desert petroleum inc.

RE: Revision to 4035 Park Boulevard, Oakland, CA 94602 Work Plan, dated May 1, 2003 to 1) investigate impacted soil contamination both above and below the groundwater table, 2) investigate the vertical extent of contamination in groundwater and 3) update the RBCA Tier II to evaluate remediation options. This revision expands on the bullet items you e-mailed Western Geo-Engineers Friday, October 24, 2003.

RE: Revision to 4035 Park Boulevard, Oakland, CA 94602 Workplan, dated May 1, 2003; 1) investigate impacted soil contamination both above and below the groundwater table, 2) investigate the vertical extent of contamination in groundwater, and 3) update the RBCA Tier II to evaluate remediation options. This revision expands on the bullet items you e-mailed Friday, October 24, 2003.

# FIGURE 3- PROPOSED HOUSES SEWER DISCHARGE TREATMENT COMPOUND WASTEWATER DISCHARGE PERMIT # 5043550 1 (Revised 10/27/03)

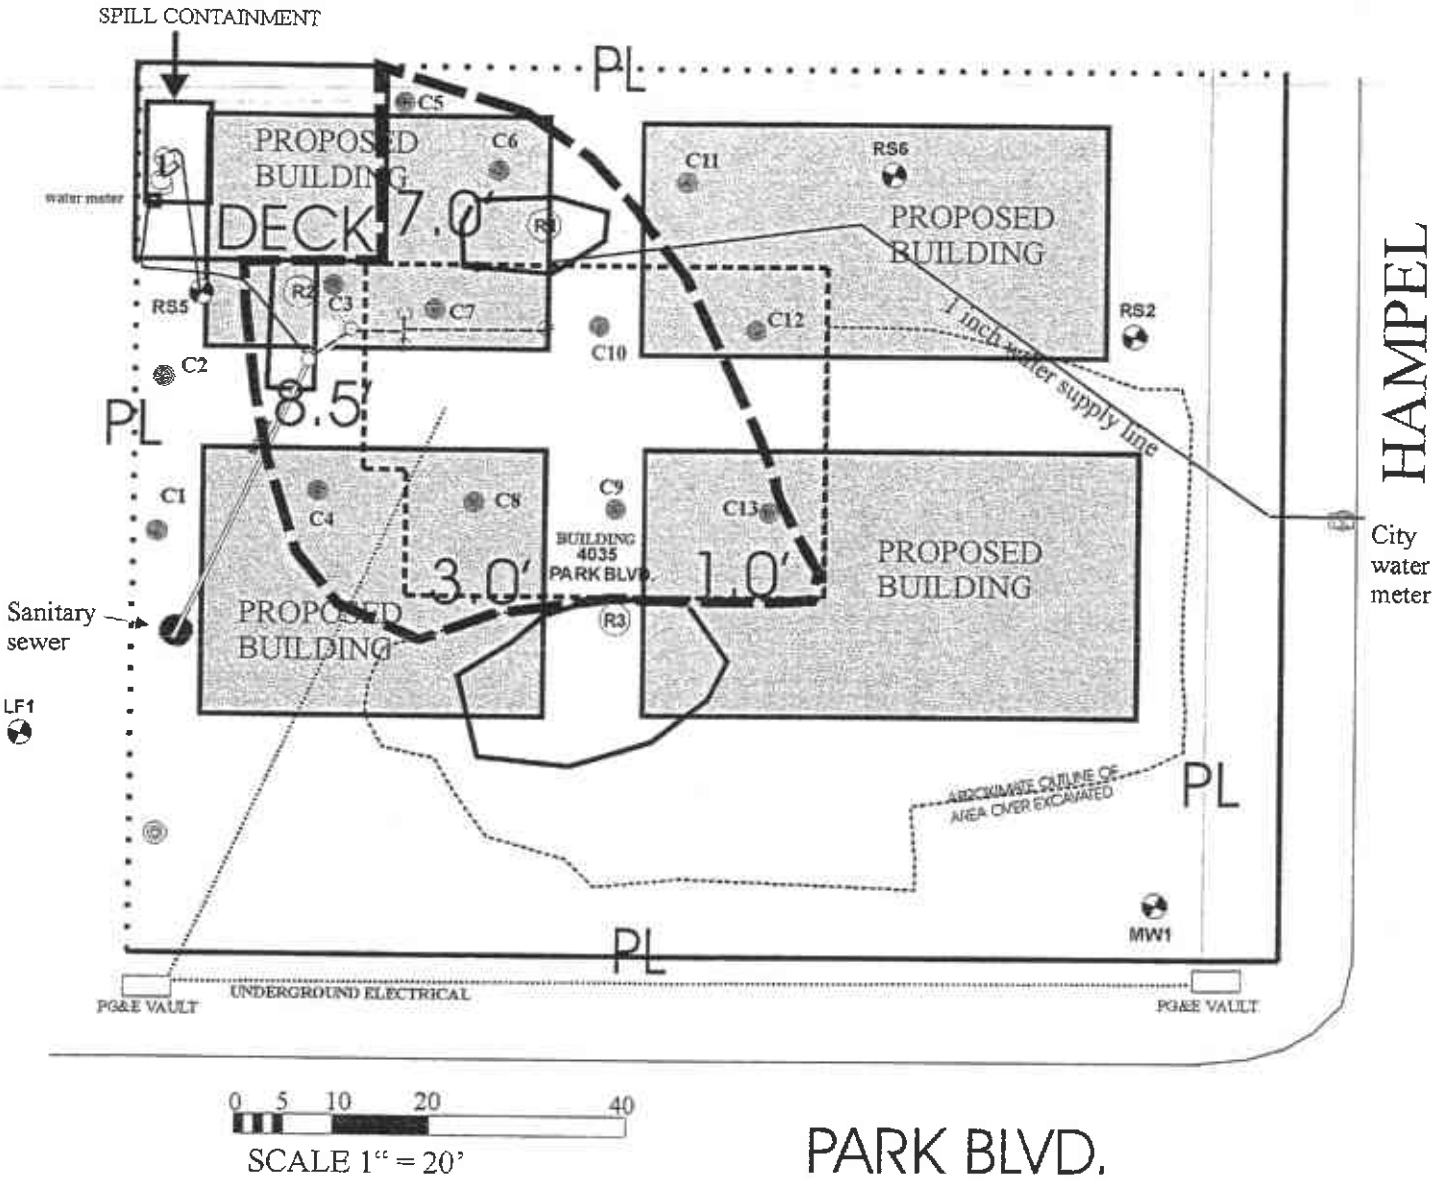
- 1. Review of on-site boring logs failed to reveal a cobbly backfill material that you felt may cause a problem should a GeoProbe be used to complete this phase of work. You mentioned that the R1 and R2 trenches exposed that material. See if you can find some info in your records that might help how where this fill should be anticipated, depths, etc.*

*4. Please clarify expected depths of each boring.... We expect that it should be a 50' depth.*

I reviewed the Over-Excavation and Quarterly Ground Water Sample Report, dated November 24, 1995. Appendix E - Field Notes, show the cobble layer beneath the then present station building, exposed by over-excavation at the now present well R3. The depth varied from 1 foot at the southeast corner of the building to 3 feet at the southwest corner of the building. Upon removing the hoist inside the building, the fill rock "cobble" was found to be as deep as 5 feet below the surface. Exploration trench (well R2-west of building) exposed the cobble to the 8.5 foot depth and exploration trench (waste oil UST area, R1-north of building) exposed the cobble to the 7 foot depth. I have included a revised Figure 3 that outlines (heavy dash line) what I feel is the extent of the cobble fill with bold numbers indicating depth to base of fill.

Examination of soil sample results from past assessments indicate that RS-5 bottom soil sample obtained at the 40 foot depth contained trace amounts of gasoline range hydrocarbons. It is proposed that the initial borings/cores (C1 through C5) be performed to the 50 foot depth. Based on field evaluations the remaining cores would be performed at somewhat of a lesser depth. Field evaluations will be evidence of staining, odor and PID response.

The property structures have been demolished to allow for the construction of residential buildings on this property. To evaluate the best means to further the remediation of gasoline contaminants associated with this site and the risk these residual soil and groundwater contaminants may have on the future development of this property, soil and groundwater samples are necessary. Figure 3 shows the locations of the former gasoline station building, the areas that were over-excavated (removing the majority of gasoline contaminated soils), the locations of the groundwater monitoring wells and the proposed building locations. Test holes for obtaining soil and groundwater samples will be placed at approximately 15 foot spacing in the northwest corner of the lot.
